Official Transcript of Proceedings
NUCLEAR REGULATORY COMMISSION

Title: Advisory Committee on Reactor
Safeguards
EPR Subcommittee

Date: Tuesday, November 3, 2009

Chapter 8, Electric Power: Chapter Topics

Alignment for EDG No.1 in Maintenance

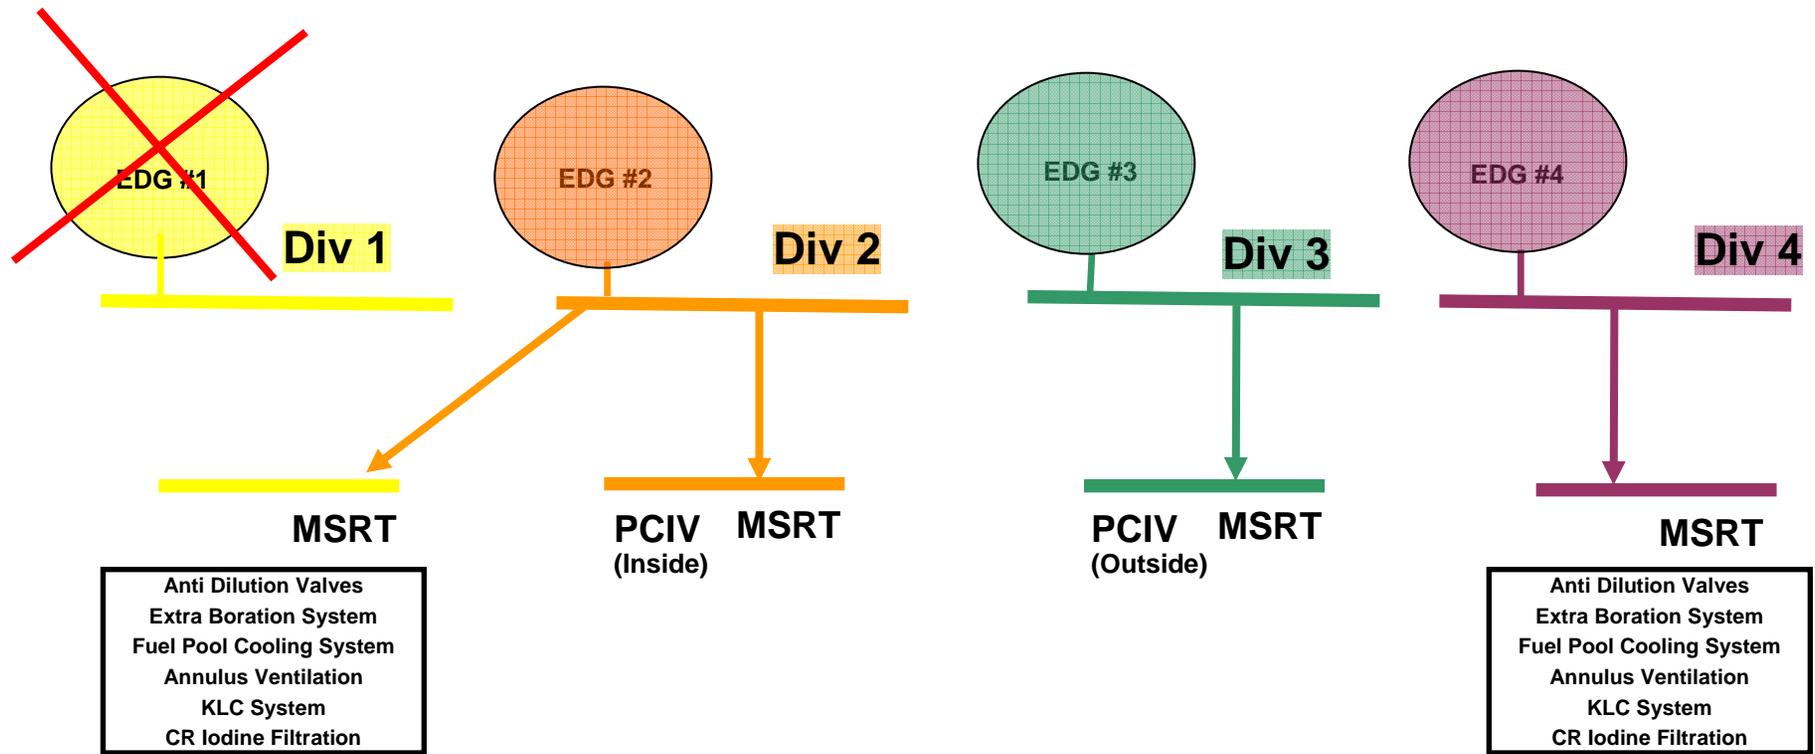
7 MEMBER STETKAR: So that's a four-month
8 maximum time. If people perform rolling preventive
9 maintenance during plant power operation, there
10 could be a measurable fraction of time when you're
11 actually operating the plant in this alternate power
12 alignment. I have no idea. There's no experience
13 in the United States. I'm a bit familiar with
14 plants in Europe where the kind of rolling
15 preventive maintenance durations last anywhere from
16 two to four weeks.

6 The second question is, the second
7 bullet under the response that says, "Stated there's
8 no significant change in risk." When I asked AREVA
9 whether they'd used the risk assessment, for
10 example, to evaluate the 120-day LCO time limit for
11 the diesel generator, I think said no they hadn't
12 used the risk assessment.

14 MEMBER STETKAR: It's I guess
15 interesting. Did they provide differences in the
16 actual risk assessment results or design that had
17 the alternate feed configuration and a design that
18 did not have the alternate feed configuration to
19 show what the actual difference in risk is? This,
20 as I understand it, that bullet says there is no
21 significant change in risk, I'm assuming, from the
22 alternate feed configuration --

11 MEMBER STETKAR: -- that's. I don't
12 want to quibble over numbers. I was curious what
13 assumptions were built into that differential
14 calculation in risk, because it could be very
15 strongly influenced by the assumed fraction of time
16 that you remain in that alternate line up
17 configuration. If in the fact the plant does a
18 rolling preventative maintenance outage schedule and
19 you have one diesel out for two to four weeks a year
20 per diesel, you could be as much as two to four
21 months out of the year that you're actually in that
22 particular configuration, which is a fairly large
23 fraction of the time. I have no idea whether those
24 are reasonable numbers.

2 MR. KANG: Yes, four-division. And the
3 staff asked these questions in one of RAIs, and what
4 is the risk increase to these configurations. But
5 they were saying it is negligible, less than a
6 percent. Okay? So, the way I understand is if the
7 risk is less than a percent, you don't have to
8 perform the evaluations.

4 MR. KANG: Two response. And the first
5 one was just what I ask was under these
6 configurations what kind of a risk was represented.
7 But that's probably what they came in with a
8 negligible, because one less than a percent. But in
9 the long-term, risk, what you refer to, is the staff
10 has not articulated. But on the other hand, we do
11 ask that staff would express the concern. This is
12 120 days too long and ask for the justifications.
13 And they did provide that this is came from the reg
14 guide. And also, if you have a better
15 configurations then two-divisional concept that you
16 could have a linear or more LCO time. But, it was
17 not really -- this number what I have here is
18 probably just a snapshot of the configuration risk.

U.S. EPR ETAP SLD, From EDG

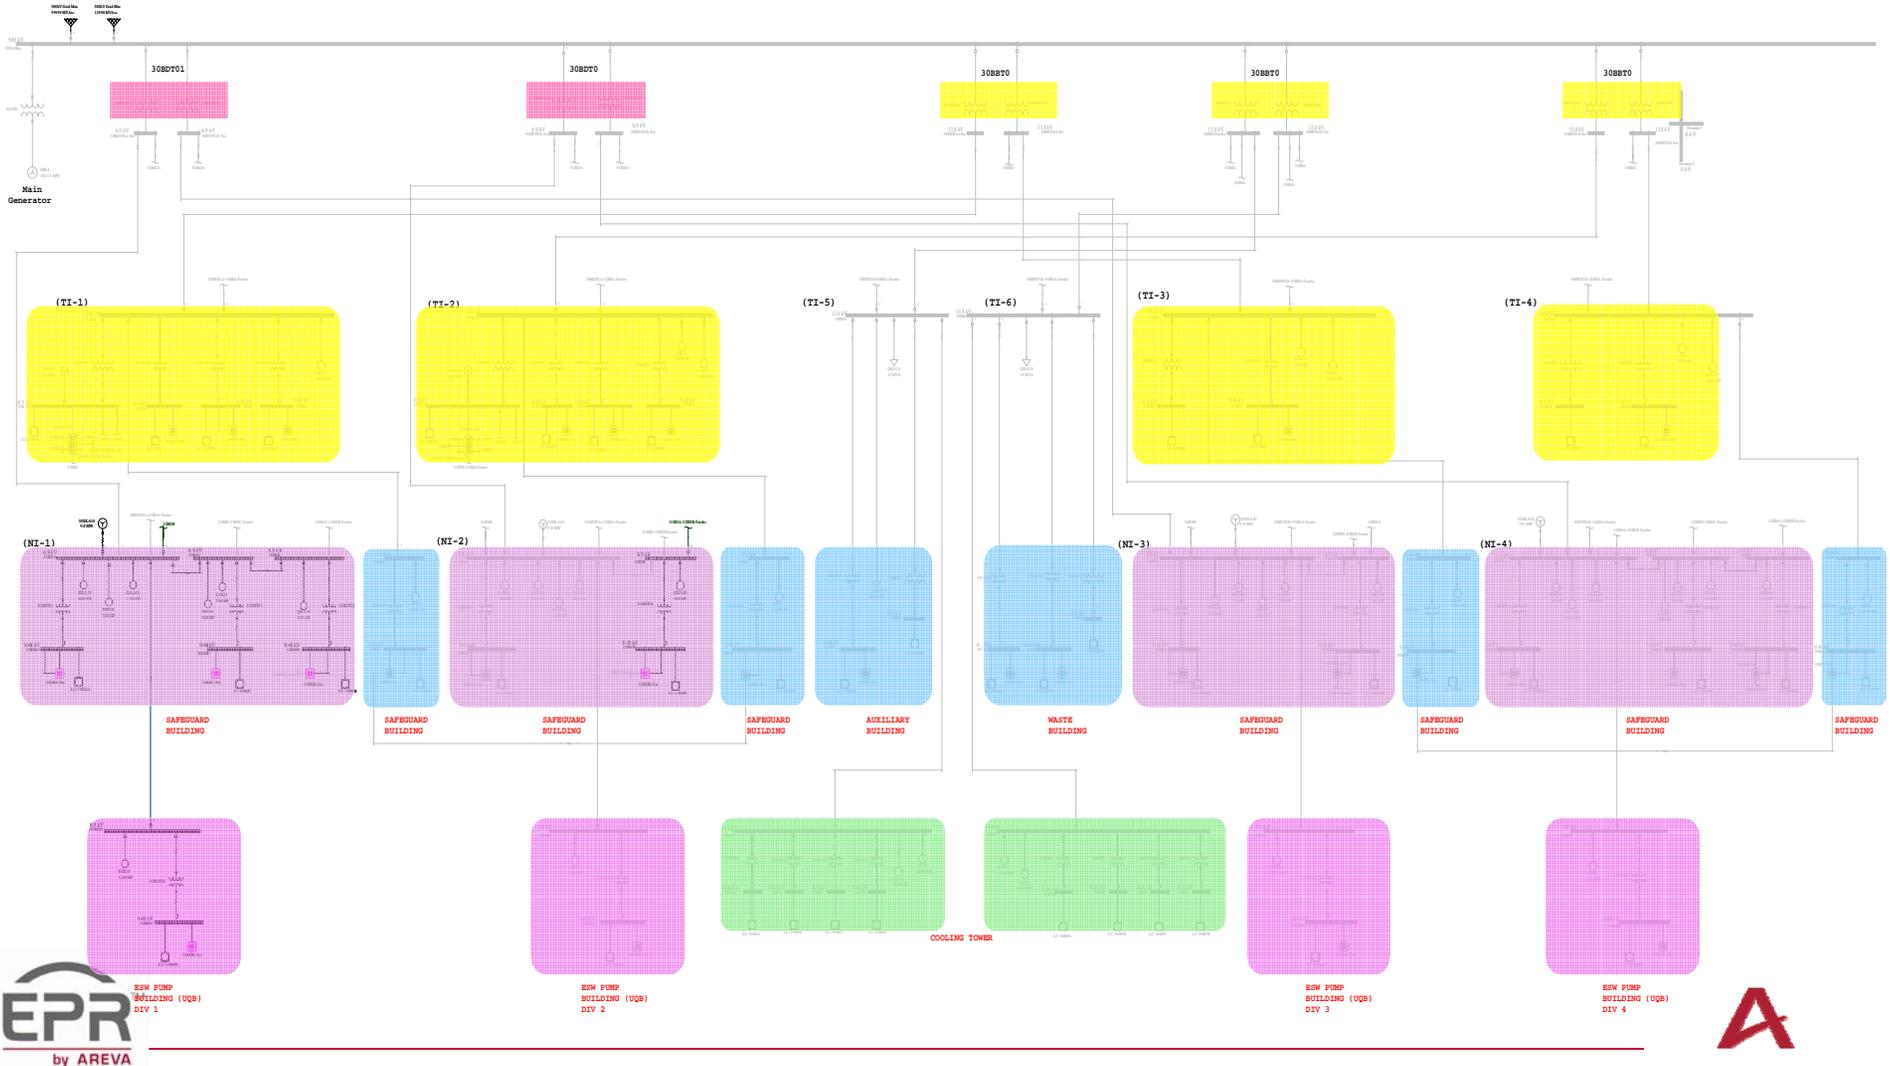
13 CHAIRMAN POWERS: Well, I guess my
14 principle question may turn to the staff. Is this
15 model actually used in the safety analysis? I mean,
16 most of the things you spoke of, if I were a
17 customer and buying one of these, I'd want to --
18 you'd be here for days.

12 DR. SALAMI: Maybe I just can add
13 something which maybe not directly answer your
14 question. Maybe you're thinking about safety
15 evaluation. For example, when we have a alignment
16 from EDG, as you see here, we establish that we able
17 to start the component if the power fed from the
18 EDG. The motor can start under the condition that
19 it's power from the EDG. To me, EDG is a safety
20 function and --
